13. (HDP-4-Q13) Comment: The information provided does not allow the staff to determine whether the background bedrock monitoring wells are located in appropriate sampling locations.

Figure 35
Groundwater Flow Map: Jefferson City Formation, September 2008

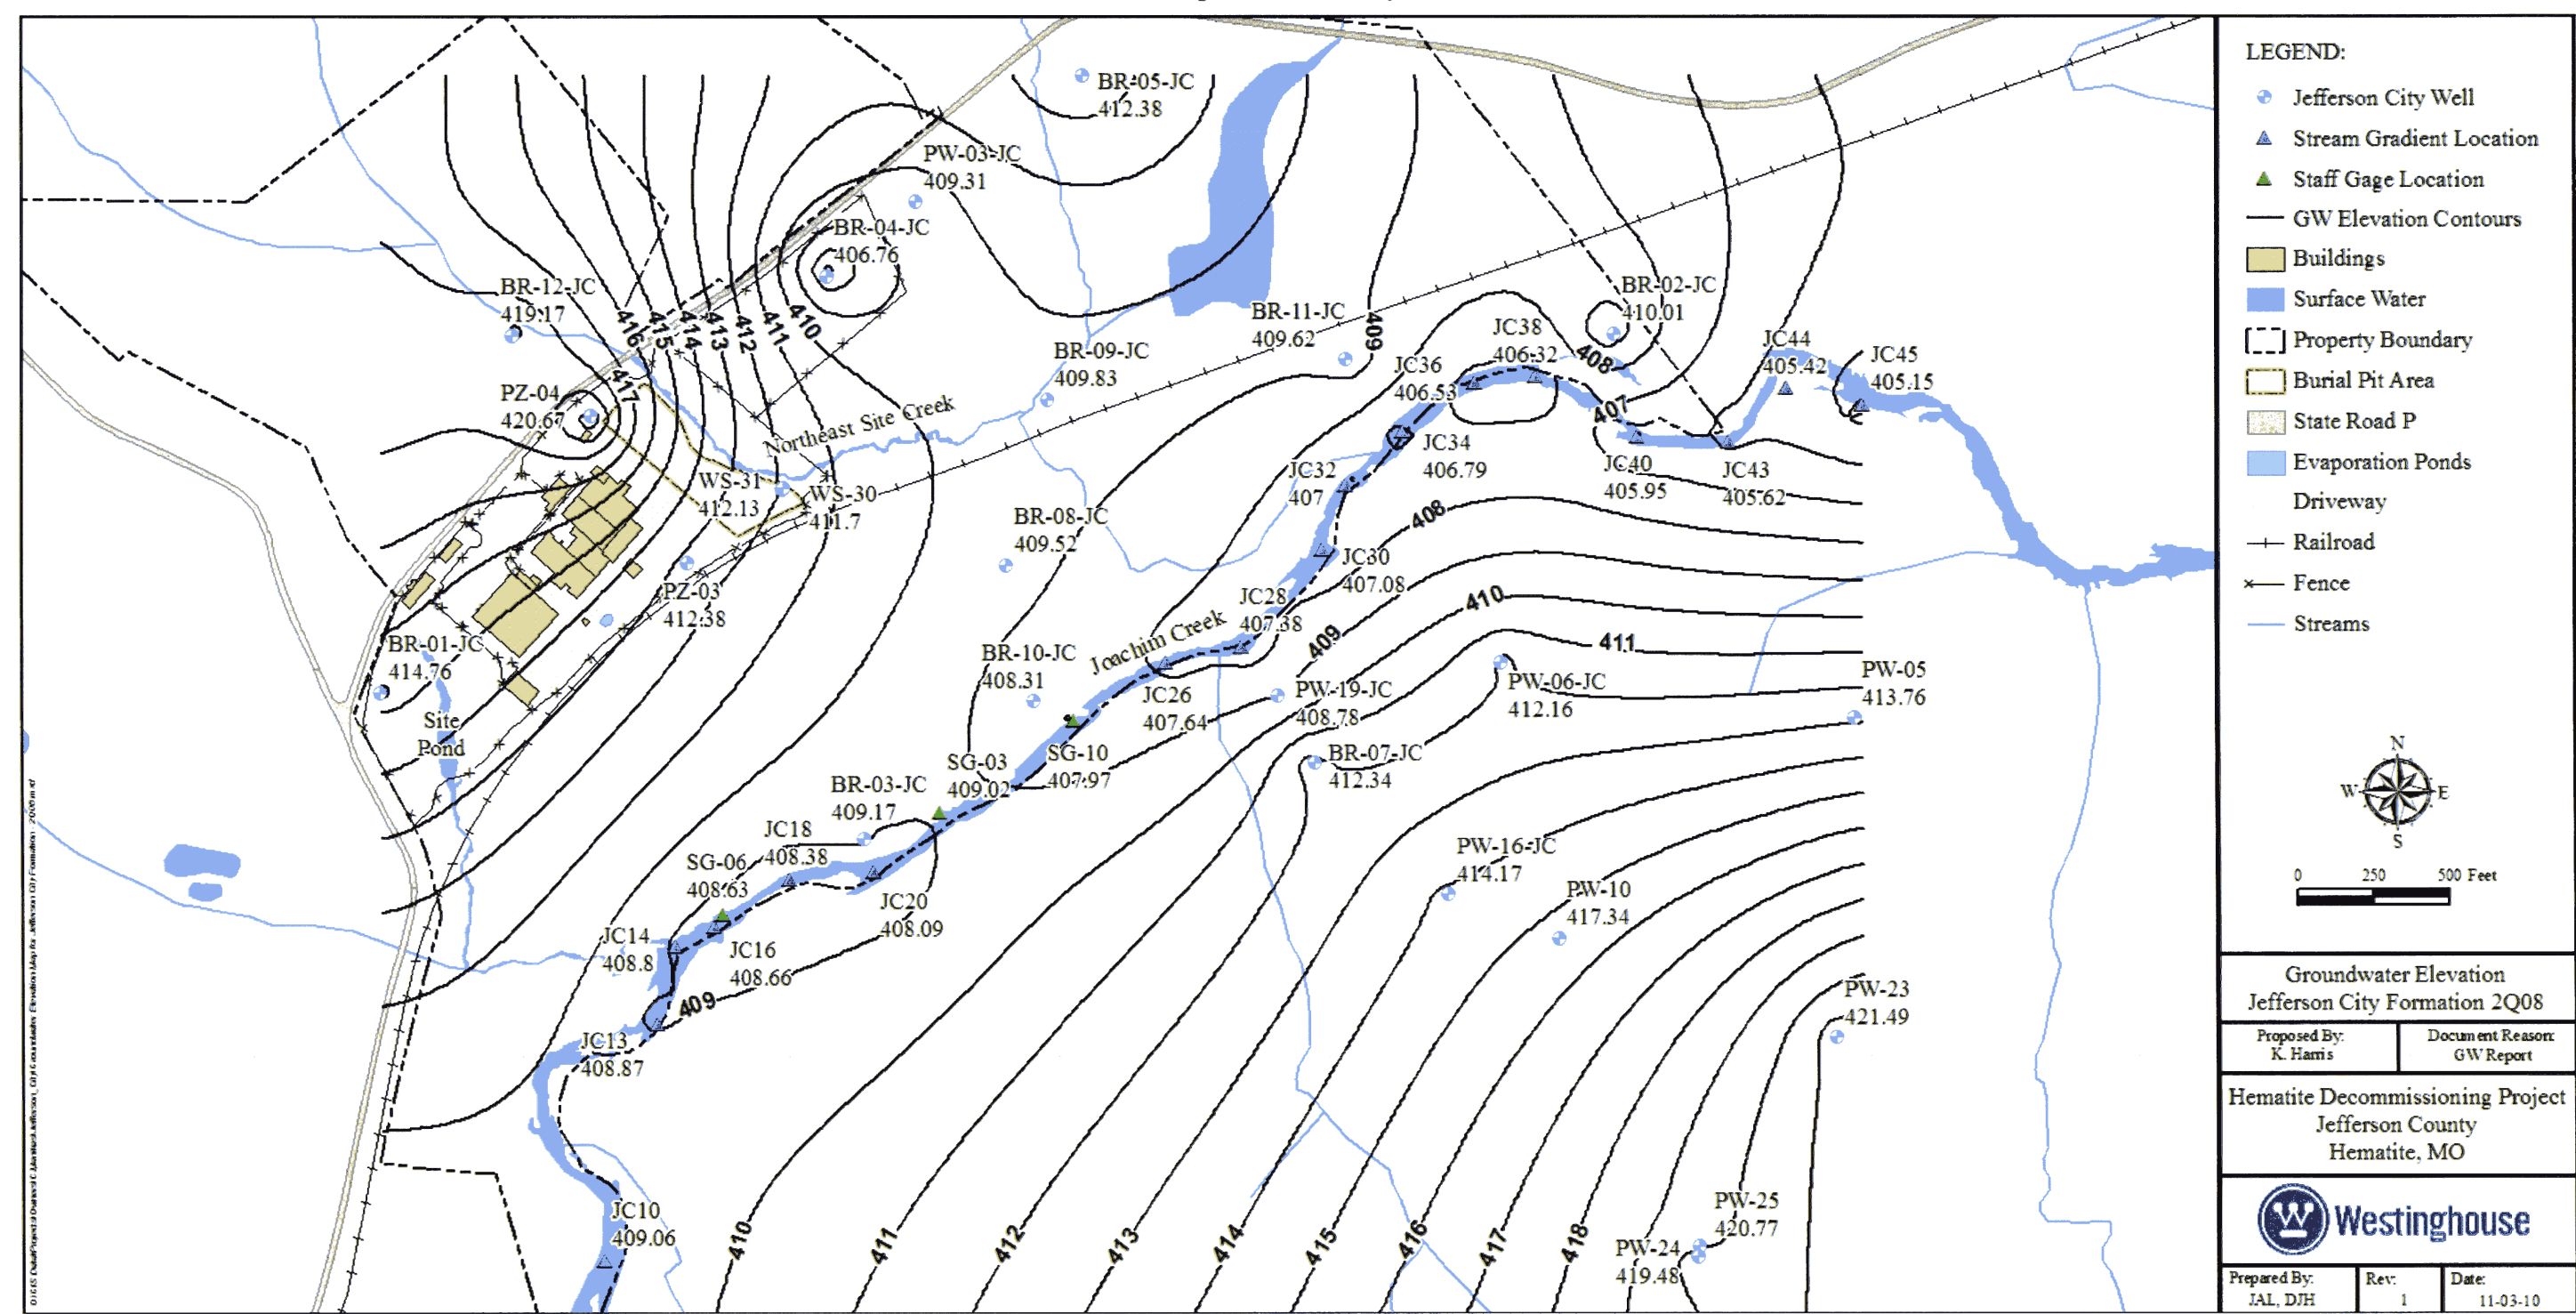
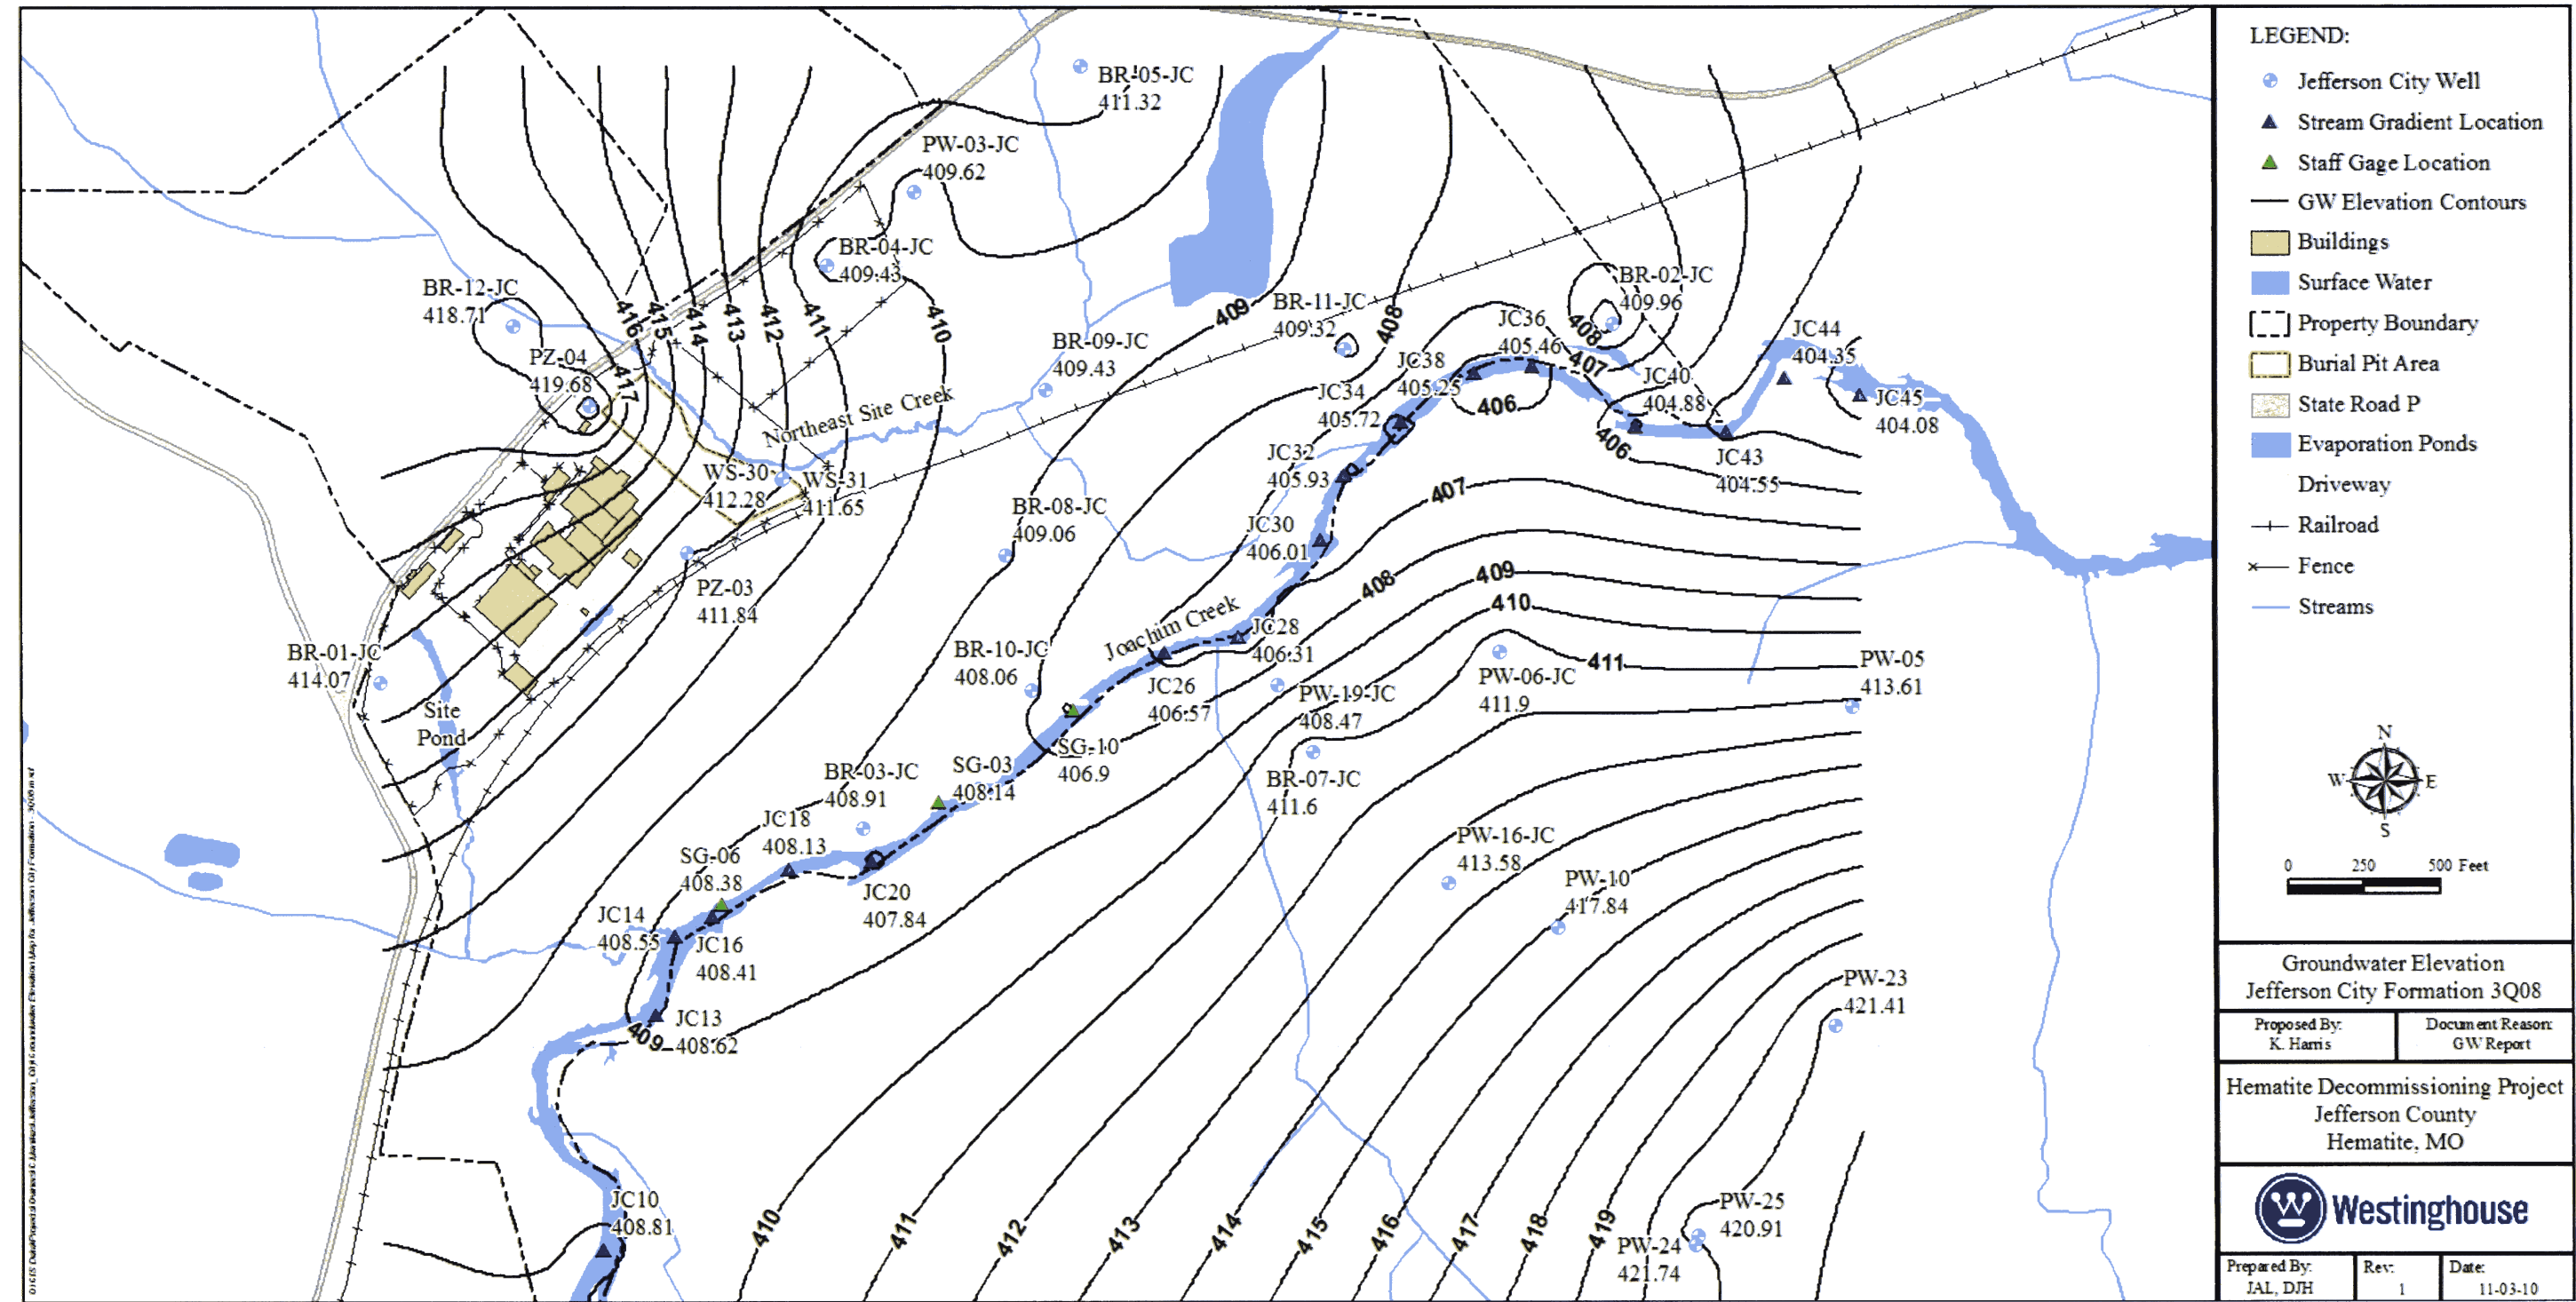
Basis: Figure 3-32 in the HDP indicates that well BR12RB may be down gradient of the site, but the figure lacks sufficient detail to provide a clear understanding of the groundwater flow regime. This ambiguity is significant because bedrock well BR12RB appears to have the highest level of 234U when compared to all other bedrock well data provided in the Radiological Characterization Report.

Path Forward: Provide figures for all bedrock well locations. The figures should include detailed potentiometric elevation maps for each bedrock unit pre and post Festus municipal well shut down.

Water levels measured during the quarterly Interim Groundwater Monitoring Program (IGMP) events from the second quarter of 2007 to the third quarter of 2010 (also post Festus municipal wells shutdown) were used to develop groundwater flow maps for the Jefferson City and Roubidoux bedrock formations. Please note that the groundwater flow maps for the Jefferson City bedrock formation were recently updated to include data from stream gradient locations along Joachim Creek (excluding the 4Q09 and 1Q10 events when the stream staff gauges were destroyed due to flooding of Joachim Creek). The surface water elevation data was used to supplement the groundwater elevation data and to evaluate the relationship between the Jefferson City aquifer and Joachim Creek. The groundwater flow maps for the IGMP are provided as Figures 30 through 43 for the Jefferson City formation and Figures 46 through 59 for the Roubidoux formation. In the site area, the groundwater flow maps depict a general groundwater flow direction for the Jefferson City formation to the east-southeast, and for the Roubidoux formation to the northeast.
